Placer County Office of Education

RFP for Lease-Leaseback Construction Services

*Office Building Tenant Improvements, Annex Building Alterations,
& Site Improvements @ Various Sites*

ADDENDUM NO. 4

VAV CONTROL DETAILS

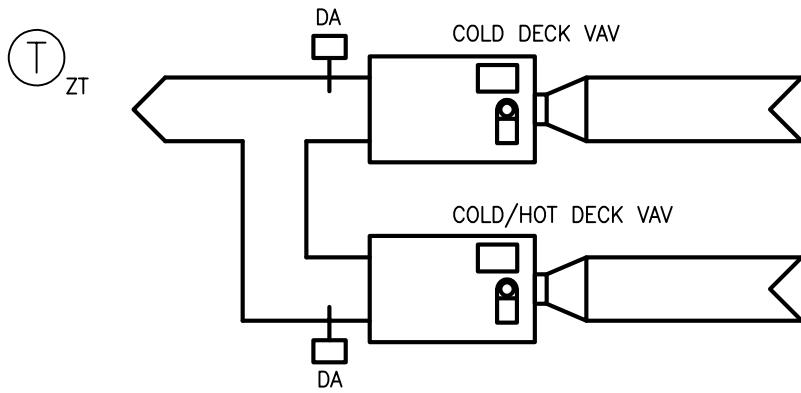
1. *New Main Office: Please provide a controls diagram for the TI office portion that can be utilized for controls subcontractor pricing.*

Response: A control diagram is being provided. **See attached detail E/M5.02.**

NOTE: EXISTING BOXES THAT ARE REMAINING AND BEING REUSED ARE HAVING CONTROLLER, STATS, ACUATORS AND DA-T REPLACED UNDER A SEPARATE SHELL CONTRACT. WHERE THIS OCCURS, RELOCATE THE ROOM SENSOR TO LOCATION SHOWN ON PLANS. NEW BOXES ARE TO HAVE NEW CONTROLS AS PART OF THE T.I. CONTRACT.

COLD DECK BOX SEQUENCE

MODULATE COLD DECK DAMPER FROM MIN. AIRFLOW CFM TO MAXIMUM AIRFLOW CFM TO MAINTAIN ROOM SETPOINT.

(NOTE: THE COLD DECK RESETS SUPPLY AIR TEMPERATURE FROM 45°F TO 60°F)

COLD/HOT DECK VAV BOXES - SEQUENCE

COLD DECK BOX MODULATES AS DESCRIBED ABOVE.

(NOTE: COLD DECK GETS VENTILATION AIR (FRESH AIR). HOT/COLD DECK DOES NOT HAVE VENTILATION AIR.)

COLD/HOT DECK:
DURING WARM AMBIENT TEMPERATURES, THE DECK CONVERTS TO COLD DECK w/45°F SUPPLY AIR (RESETTABLE). WHEN AMBIENT TEMPERATURES BECOME COOLER (AS DETERMINED THRU THE AC UNIT LOGIC), THE DECK IS CONVERTED TO NEUTRAL AIR (NO HEATING OR COOLING - JUST RECIRCULATION OF PLENUM AIR. UPON FURTHER ZONE REQUEST FOR HEATING, THE DECK IS CONVERTED TO HEATING DECK. HOT DECK IS ±115°F (ADJUSTABLE).
